## ADDENDUM NO. 1

Issue Date: May 16, 2022

Project Name: Indian River Blvd Resurfacing from 53<sup>rd</sup> St to Barber Bridge (IRC-1707)

Bid Number: 2022046

# ADDENDUM #1

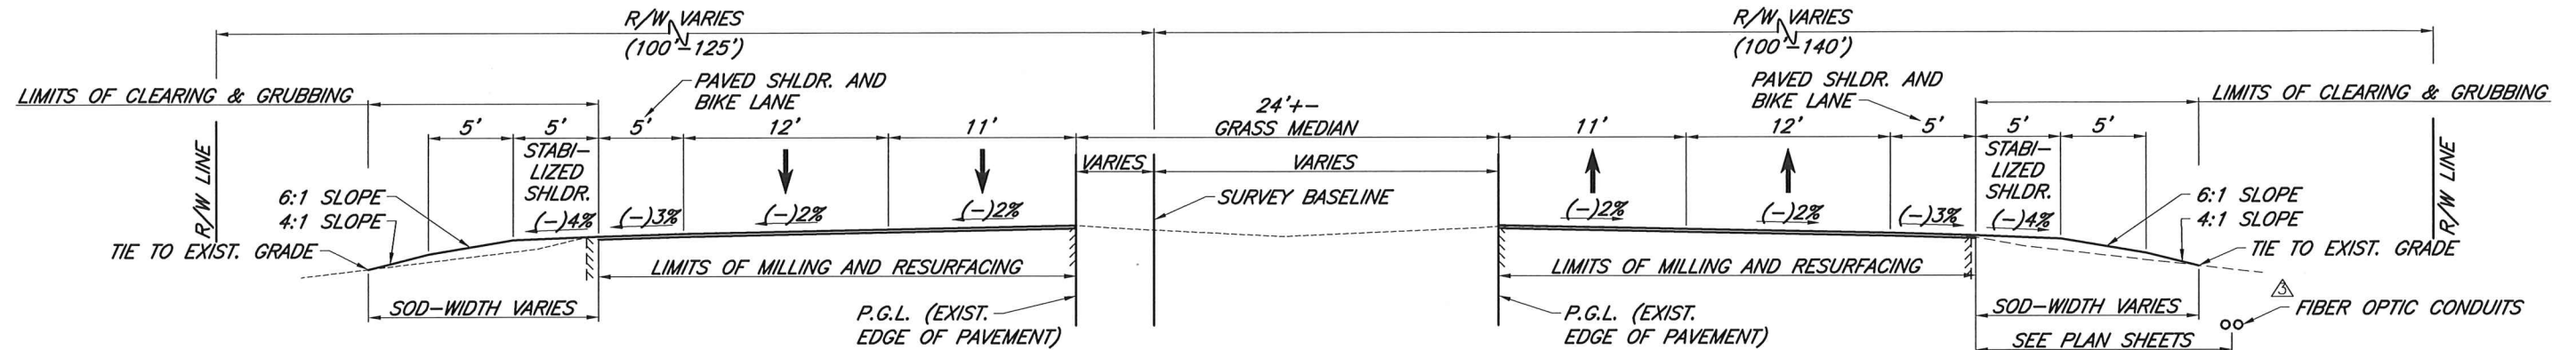
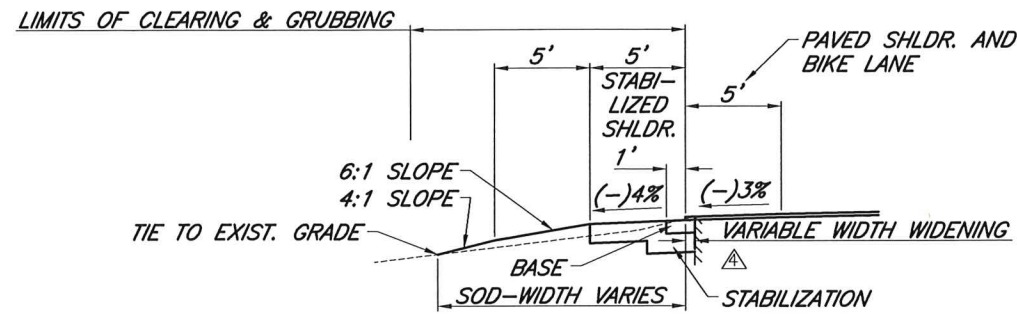
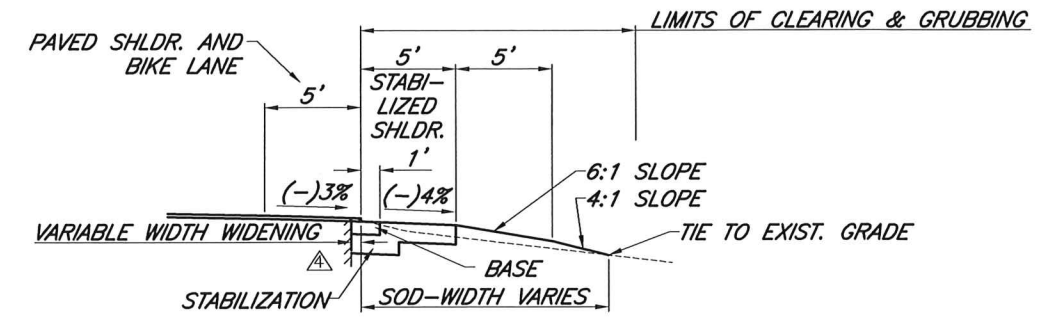
3. Sheet 3 of 51 shows a widening detail consisting of Base Group 6. How will this work be paid? **We have a pay item for Optional Base Group 11. Plan Sheet 9 - Addendum 1 shows the corrected quantities for Optional Base Group 11 and an added pay-item and quantity for Optional Base Group 6.**

8. See widening details on sheet 3 of 31. Where does the 2' asphalt widening occur, besides adjacent to the three traffic islands? In order to do a takeoff, we need to verify the 2916 SY of OBG11, I cannot find the entire 2916 SY of cemented coquina. The widening details say "Stations and locations vary", could you identify where this work occurs so we may perform a quantity takeoff? **Plan Sheet 3 - Addendum 1 shows the updated quantities for Optional Base Group 11 and Optional Base Group 6 and specifies the limits of the widening.**

LIMITS OF BASE WIDENING			
LEFT OF BASELINE	MAXIMUM WIDTH	RIGHT OF BASELINE	MAXIMUM WIDTH
500+06 - 505+86	2.7'	501+41 - 505+30	1.7'
550+67 - 551+59	2.2'	506+22 - 516+65	1.7'
571+99 - 575+18	2.5'	518+22 - 519+53	2.0'
584+85 - 587+62	3.0'	581+89 - 583+81	2.5'
589+11 - 590+11	1.5'	613+92 - 636+30	2.3'
591+59 - 592+60	1.5'	636+64 - 637+26	1.5'
627+55 - 637+29	4.0'	638+93 - 646+36	2.1'
638+85 - 639+52	2.1'	654+49 - 656+58	2.4'
639+73 - 642+11	2.4'

ADD LIMITS OF BASE WIDENING - ADDENDUM #1 5/9/2022 KPH
